COUNCIL ASSESSMENT REPORT

Panel Reference	2016SYE036
DA Number	DA212/15
LGA	Lane Cove Council
Proposed Development	Construction of a mixed use development comprising a non-residential podium, 429 apartments and associated car parking and upgrade works to Friedlander Place.
Street Address	496-498 and 500-520 Pacific Highway, St Leonards
Applicant/Owner	New Hope Ving Project Pty Ltd Lane Cove Council (Friedlander Place)
Date of DA lodgement	December 2015 (Original proposal) November 2017 (Amended proposal)
Number of Submissions	10
Recommendation	Approval subject to draft conditions.
Regional Development Criteria (Schedule 4A of the EP&A Act)	General development over \$20 million Development that has a capital investment value of more than \$20 million.
List of all relevant s79C(1)(a) matters	Lane Cove Local Environmental Plan 2009 Lane Cove Development Control Plan 2010 State Environmental Planning Policy No. 65 – Design Quality of Residential Flat Development State Environmental Planning Policy (Building Sustainability Index) 2004 State Environmental Planning Policy (Infrastructure) 2007 State Environmental Planning Policy 55 Remediation of Land Airports Act 1996 and Airports (Prot

Figure 1: Section of basement cut out to accommodate tree T47 root zone. (Source: Urbis)

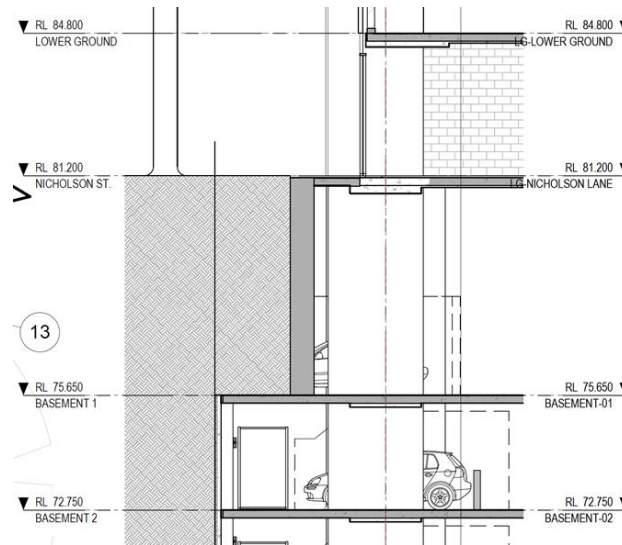
The original Arboricultural Impact Assessment recommended that six trees (T47, T48, T49, T52, T53 and T55) be removed because basement excavations on the subject site would involve root incursions and compromise the long-term survival and growth of those trees or undermine their structural stability.

Physical exploration of the trees' rootzones has now been undertaken to verify the actual location of tree roots in relation to the proposed development. A revised Arboricultural Impact Assessment has been provided as Appendix H of the amended Statement of Environmental Effects.

This trenching reveals that, for the majority of the trees, very few roots would be impacted by the proposed development with the exception of T47 where major roots were found to cross the boundary.

Accordingly, five of the six trees originally recommended for removal would not be impacted by the development and would not be removed. To protect Tree 47, the alignment of Basement Level 1 has been re-designed to step around the tree root zone and would not prejudice the health of the tree.

The following Figure shows a sketch section through the basement design to accommodate the root zone of Tree 47.

In order to permit the pruning of trees T53 and T55 and to address concerns regarding the retention and protection of trees on 69 Christie Street, the following condition is recommended to be included in the draft conditions of consent.

Figure 2: Future setback relationship between and the subject property and 69 Christie Street redevelopment in accordance with the current controls.

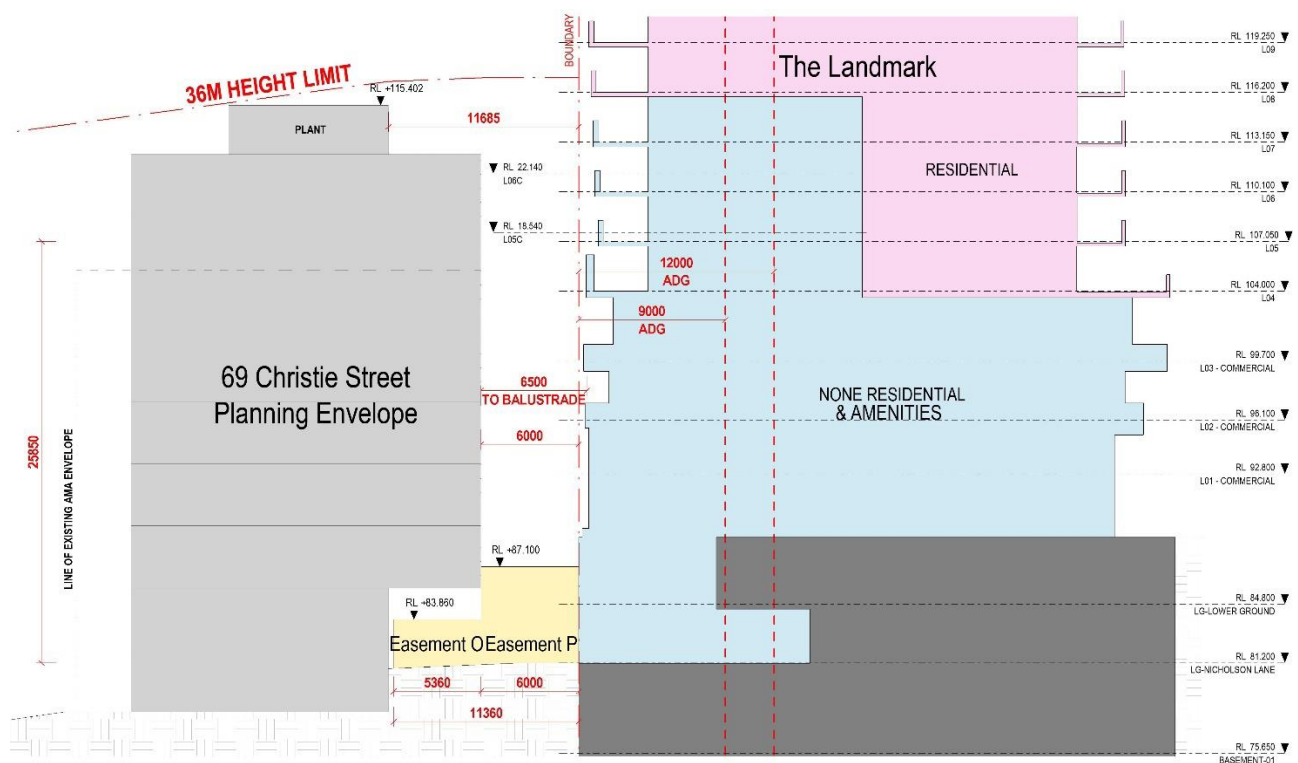
The amended proposal removes the residential interface for the extent of the current allowable building height limit on 69 Christie Street.

The diagram below indicates that the amended proposal, where the residential apartments from levels 5-7 have been deleted, would not restrict the development potential of 69 Christie Street under the present controls.

In view of the above, the amended proposal would not impact upon the development potential of 69 Christie Street St Leonards under the present planning controls. (Source: Urbis)
